Lombardo & Associates
comment prior to May 28,
2025 Planning Commission
Hearing.
-HCD-Planning

RE: Johnson/PLN210061

Re: Response to Peer Review Comments for
Proposed Development at 226 Highway 1
Carmel Highlands, California
Monterey County APN 241-182-003

SUBJECT: RESPONSE TO PEER REVIEW COMMENTS
Proposed Single Family Residence
226 Highway 1, Carmel, California (Previously 244 #3 Highway 1)
APN: 241-182-003-000

Feature A – A deposit of Quail.

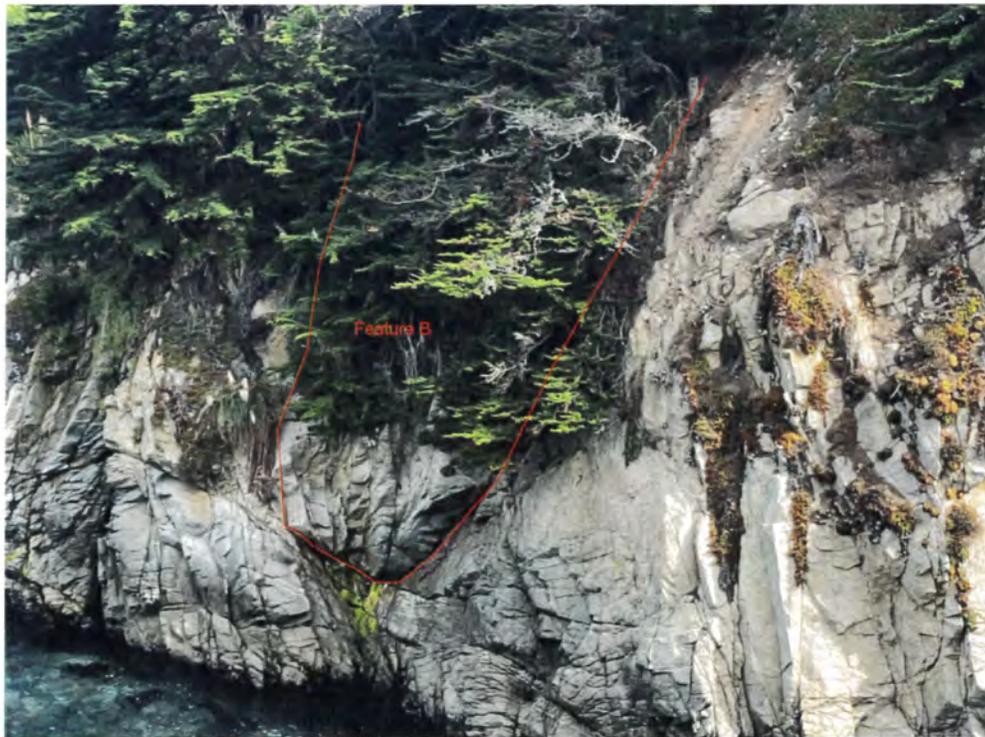
Easton Geology Response: Old alluvium (Qoal) was encountered in Exploratory Shaft 1 and is exposed in the bluff face below the site. The alluvial deposit infills an old, narrow, hillside swale. Similar ancient, infilled swales are visible in roadcuts above Highway 1 near the site. Where exposed in the bluff-face, the old alluvium is stratified and clasts are imbricated. The bluff-face exposure is unsupported yet maintains a steep slope similar to the adjacent granite and marine terrace deposits. As encountered in Exploratory Shaft 1, the alluvium is dense, normally graded, and its clay matrix is stiff. The alluvium encountered in the shaft and exposed in the bluff face is matrix supported in the upper portion of the deposit and becomes clast supported in the lower portion. We saw no shearing or offsets within the old alluvium. The soil profile exposed in the cutslope through the infilled swale in the southeastern portion of the property (above the autocourt) reveals a well developed pedogenic soil. None of the above observations are suggestive of the old alluvium or the swale it infills as resulting from landsliding. We interpret the alluvial deposits to be at least 125,000 years old based on their geomorphic position above a Pleistocene marine terrace, and they are believed to grade with the marine terrace deposits below.

Feature C – Location of headscarp.

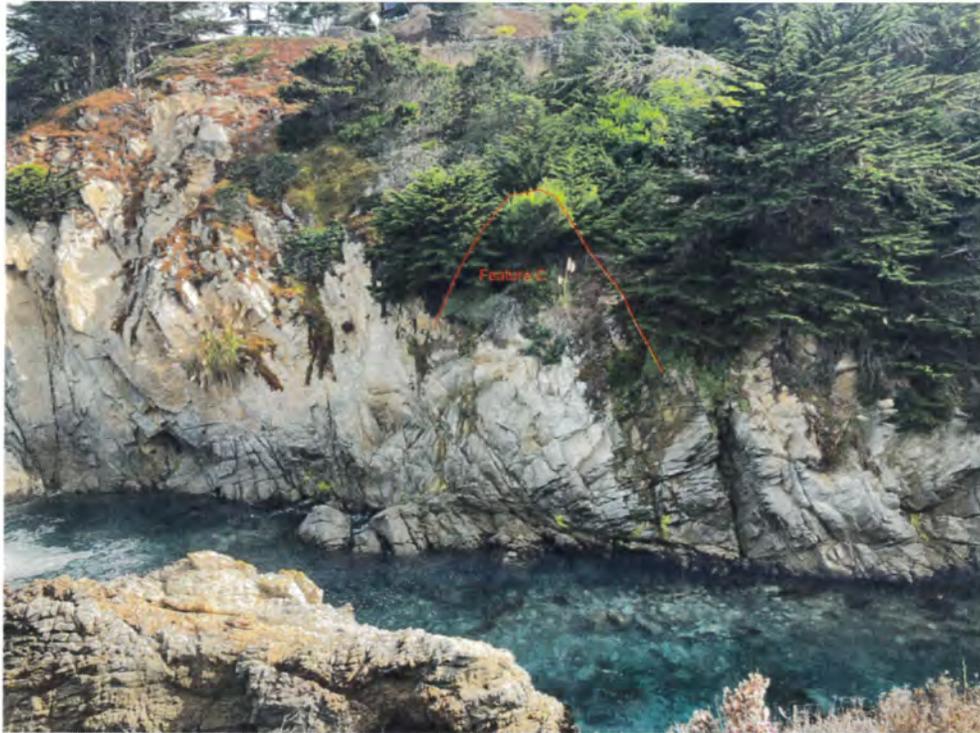
Easton Geology Response: We do not believe that Feature "C", as delineated by the reviewer, corresponds with any mapped slope instability features mapped by our firm. The location of "Feature C" on the photo markup by the reviewer lies in the northernmost portion of the parcel, is coincident with a shallow drainage swale, and appears to be 60 or more feet from any proposed improvements. The joint-bounded headscarp referenced on our geologic map was discussed above and corresponds with Feature "B" delineated by the reviewer.

Figure 5 Project Elevation Profile

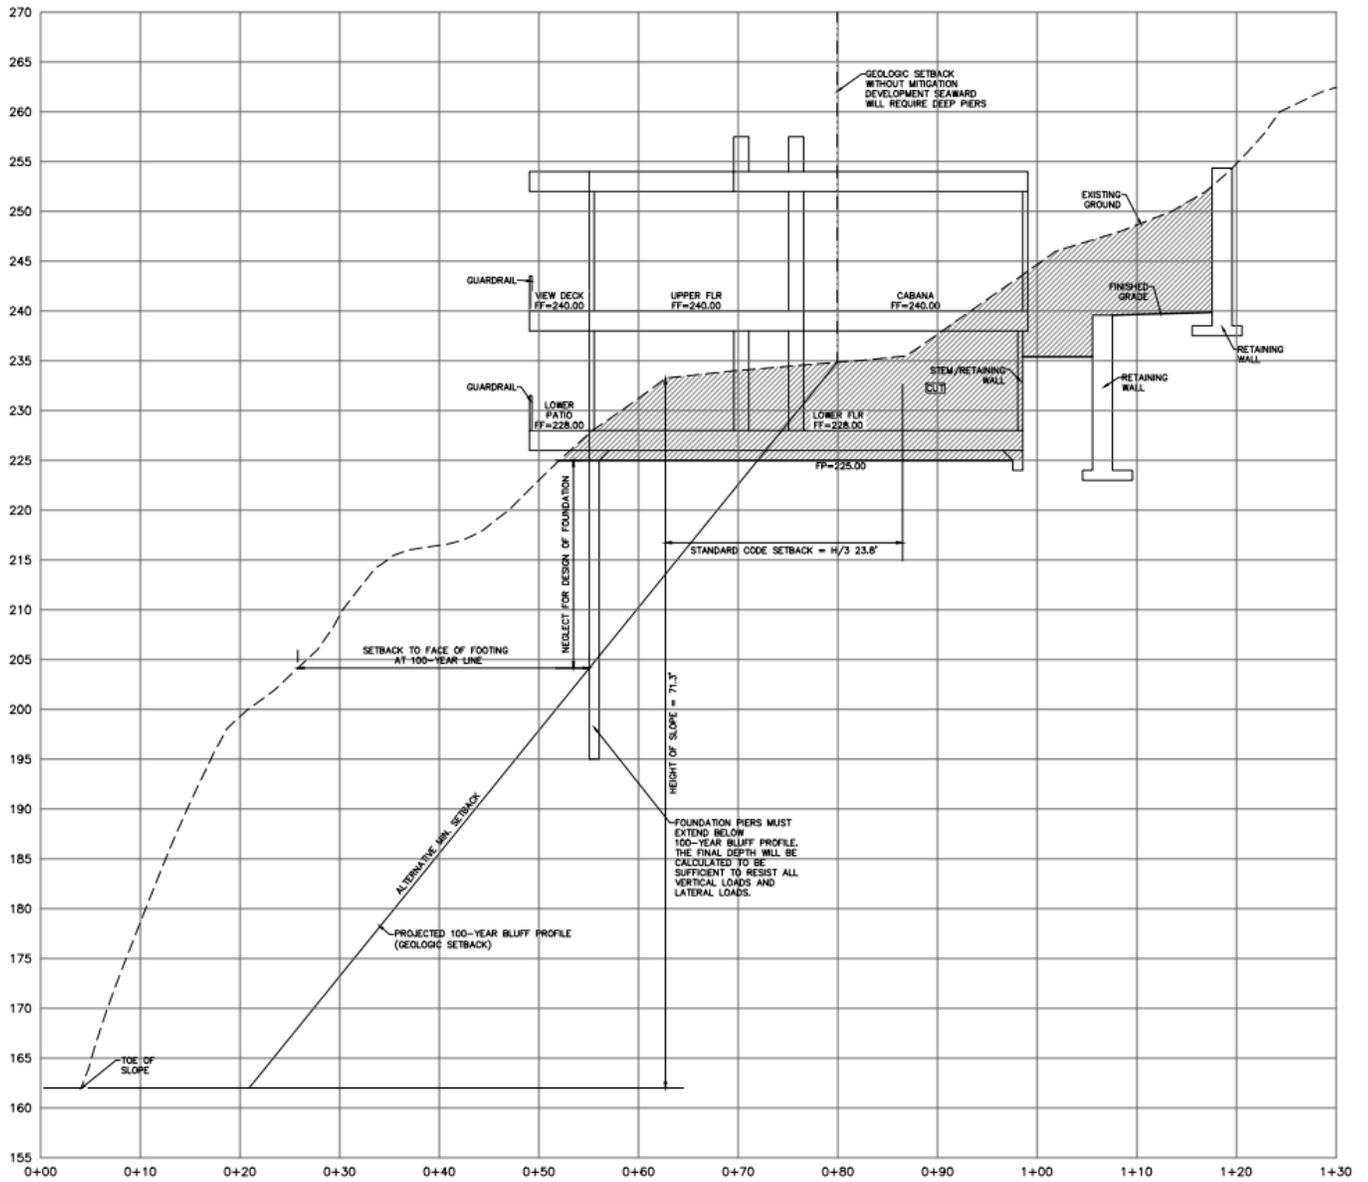
¹ Figure 5 (Project Elevation Profile) of the MND shows how the majority of the Project extends beyond the geologic setback line, protruding over the steep coastal cliff face. A copy of this figure is attached hereto as Exhibit A.
